Landscape Review Committee
Hybrid In-Person & ZOOM Online Meeting
Monday, May 12, 2025 - 12:00 PM

DATE: May 12, 2025
TO: Landscape Review Committee Members
FROM: Taylor Graybehl, Senior Planner
SUBJECT: Landscape Plan Review Application (L 8-25)

DOCKET: L 8-25 (Landscape Plan Review)

REQUEST: Approval of a street tree plan, and a landscape plan review for Tract A, in Elysium Subdivision, (Ordinance No. 5116, dockets ZC 1-22, PD 1-21, and S 1-21). The applications are submitted to address the conditions of approval.

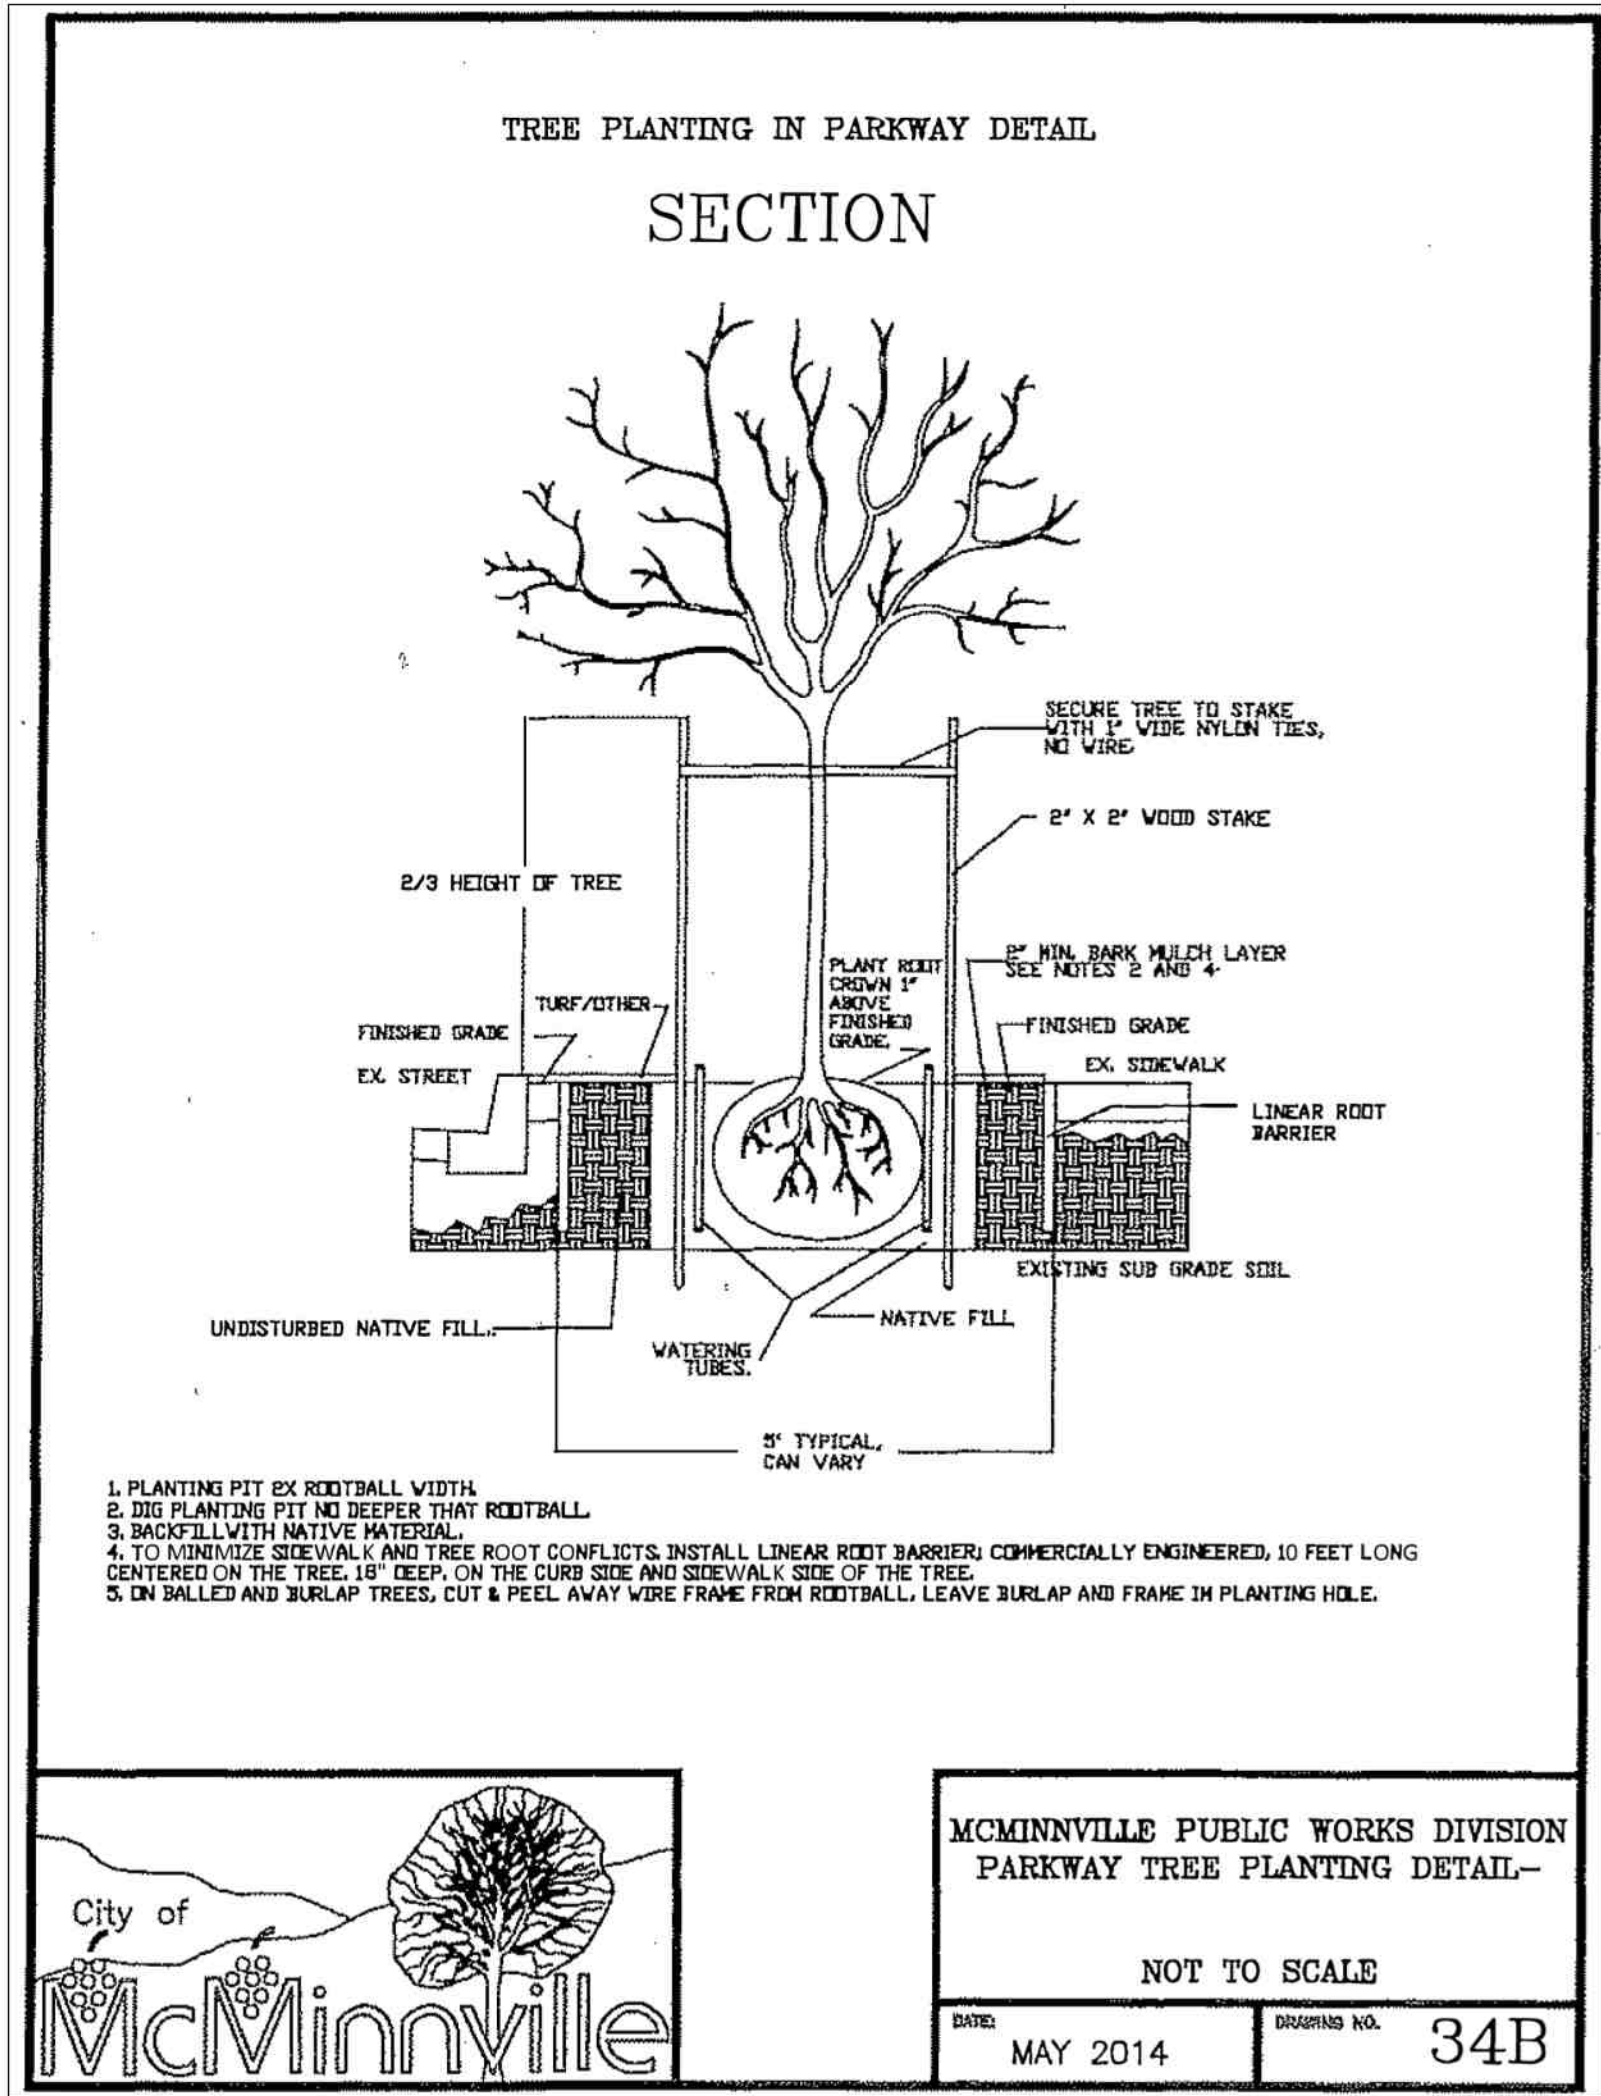
- (a) **Complies.** Two benches are provided.
- (b) **Satisfied with Condition.** The plans indicate a 4' H black chain link fence; which does not meet the condition. The applicant will be required to revise the fence type to one that meets this standard.
- (c) **Satisfied with Condition.** The plans indicate irrigation lines to dark brown tubing with gray striping. Revise plans to reflect exposed irrigation lines to be black or camouflaged from the public view.
- (d) **Satisfied with Condition.** The plans do not indicate the design of the lighting fixture or the expected foot candles on the adjacent residents. It is not possible to determine if this standard will be met. Revised plans are required that clearly demonstrate the light fixture design, showing that the lighting is shielded to minimize impact on adjacent residents.

- a. Fences in Tract A shall be a split rail open black fencing or other similarly aesthetically pleasing fence style.
- b. Irrigation lines shall be black or noted to be camouflaged from public view.
- c. Provide the design of light fixtures, showing that lighting is shielded to minimize impact on adjacent residents.
- d. Expand the width of the pedestrian connection to Jay Pearson Neighborhood Park to ten (10) feet.

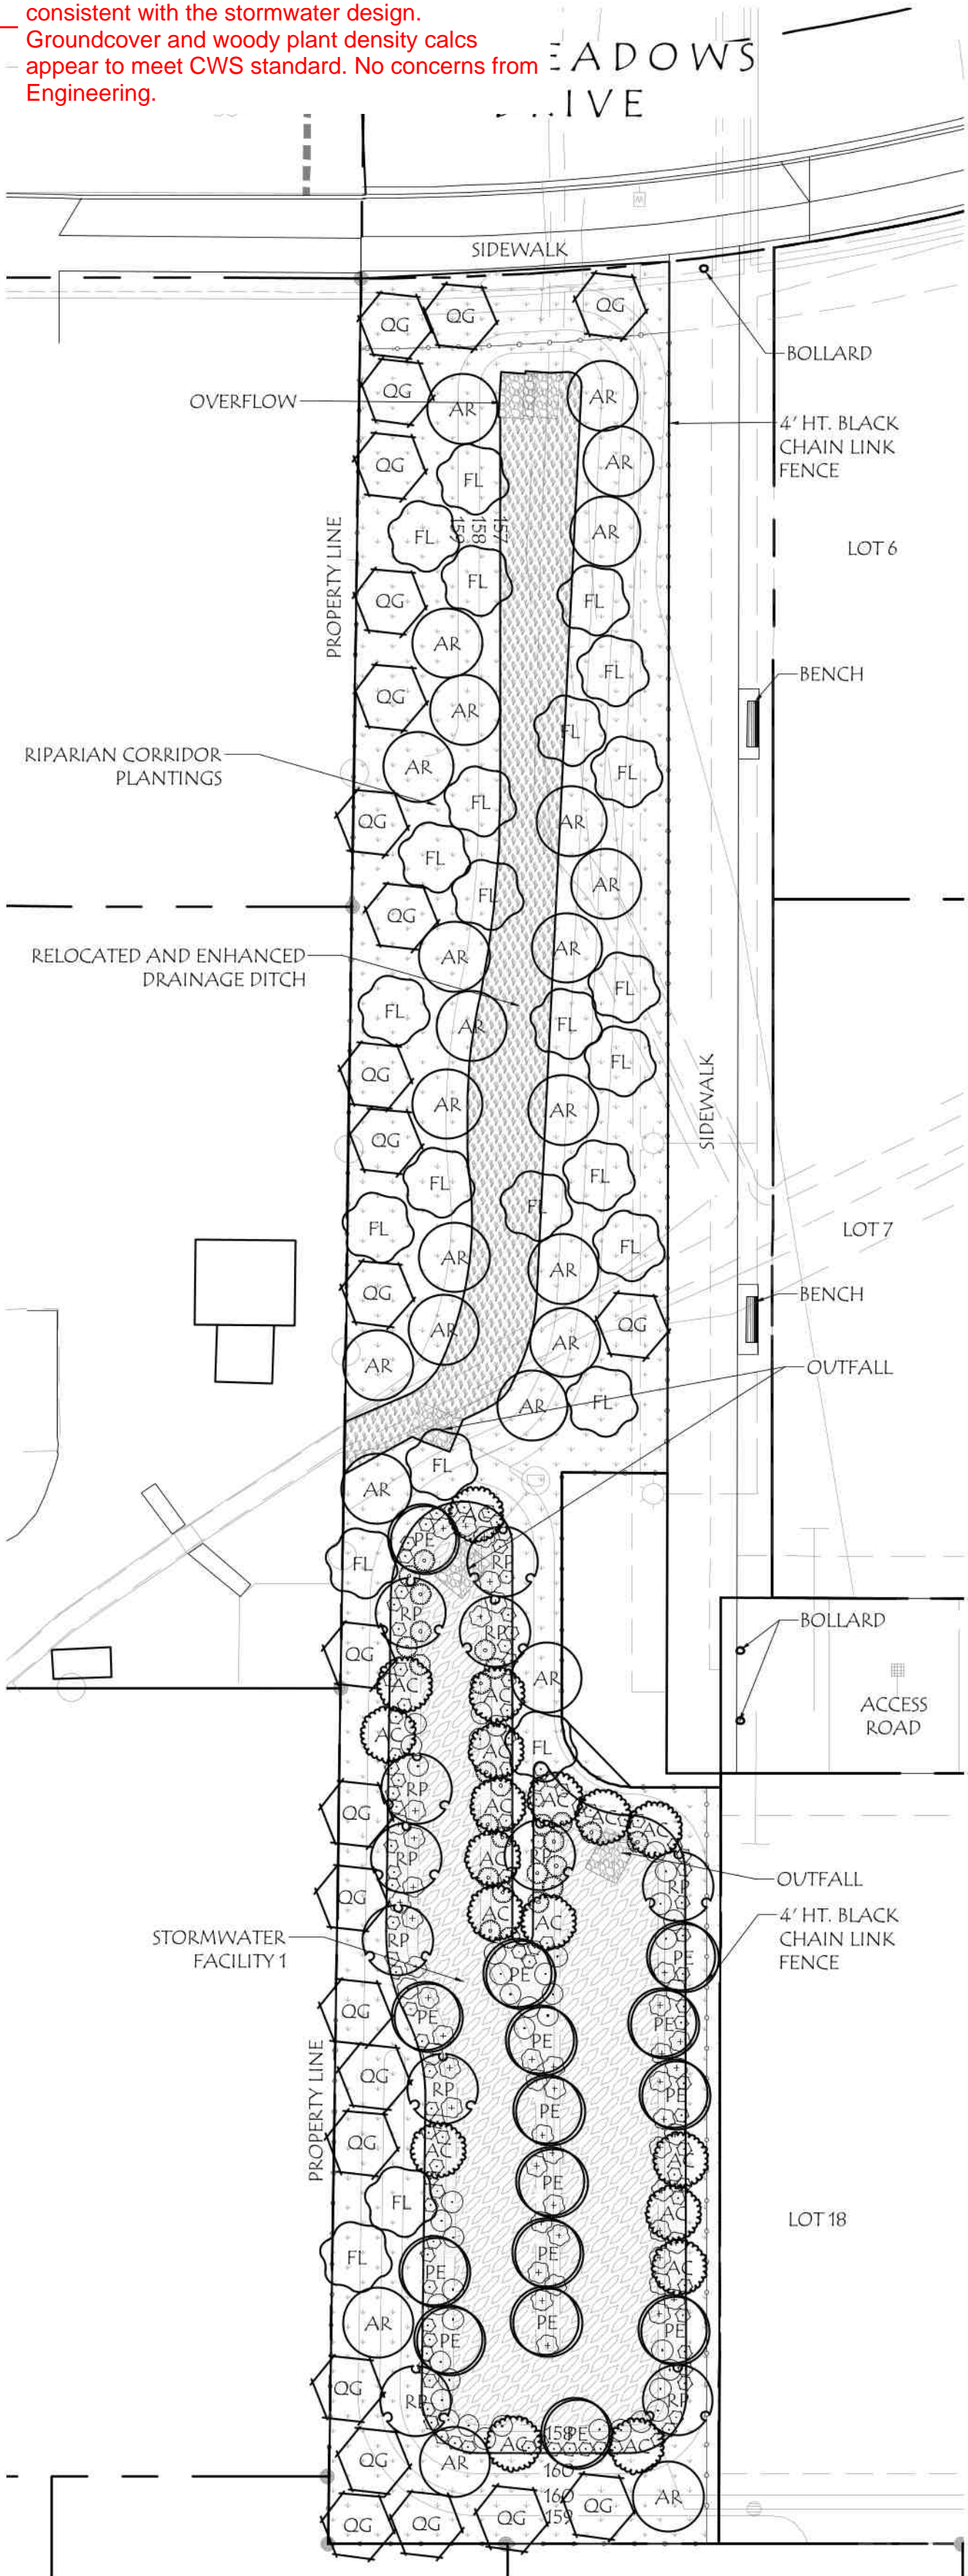
Plant selection and spacing appear to be appropriate for the inundation zones and are consistent with the stormwater design. Groundcover and woody plant density calcs appear to meet CWS standard. No concerns from Engineering.
